UNITED STATES PATENT AND TRADEMARK OFFICE

APPLICATION NO.	FILING DATE	FIRST NAMED INVENTOR	ATTORNEY DOCKET NO.	CONFIRMATION NO.
09/725,165	11/29/2000	Jose Geraldo Furtado Ramos	2764-34	8558

Office Action Summary

DETAILED ACTION

FIG. 17-4 Fluidization regimes. [Adapted from Grace, Cao], Chem. Eng., 64, 353-363 (1985).]

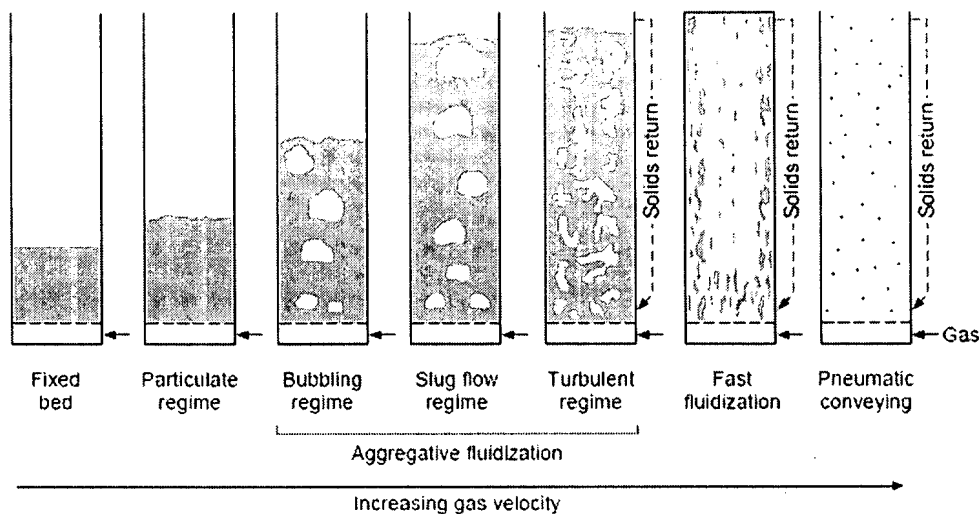
Regarding item (1), the recitations with respect to a specific level of particles within the cyclone legs (as now recited in claim 1), as well as a specific level of the fluidized bed above the junction (argued above, but not recited in claim 1 as amended), add no further patentable weight to the claims, because the specific level of the particles within the cyclone legs or the fluidized bed ultimately depends on the manner in which the claimed apparatus is intended to be operated. For instance, as is well known in the art of cyclone design, "[t]he extent to which the dipleg of a cyclone is filled with exiting solids depends on the pressure balance around the cyclone and its dipleg," (Zenz, page 813, under "Pressure Balance"). The "pressure balance", however, is a process variable and not an apparatus limitation. Also, as is well known in the art of fluidization, for a given amount of solid particulates, the level of the fluidized bed of particulates may vary

widely depending on intended use, as a function of the fluidizing gas velocity. See Regime Diagram, below (FIG. 17-4 from Perry's Chemical Engineering Handbook, 7th edition).

**JONES' radius-curved termination****APPLICANTS' radius-curved termination**

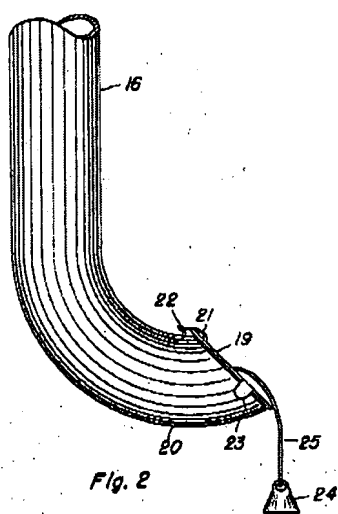
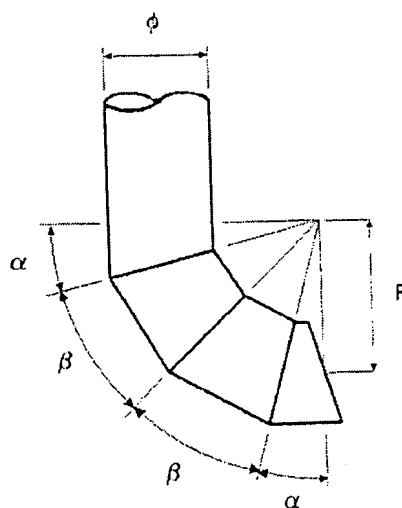
The Examiner respectfully disagrees. It is unclear as to how the radius-curved termination as taught by Jones would differ in function from the radius-curved termination as claimed by Applicants because it appears that the angle of both terminations is essentially the same (note the attached figures below).

Hence, both the radius-curved terminations of Jones and of Applicants should inherently function similarly or identically, by directing a descending mass flow of dense phase solids into a plane orthogonal to an ascending gaseous flow.
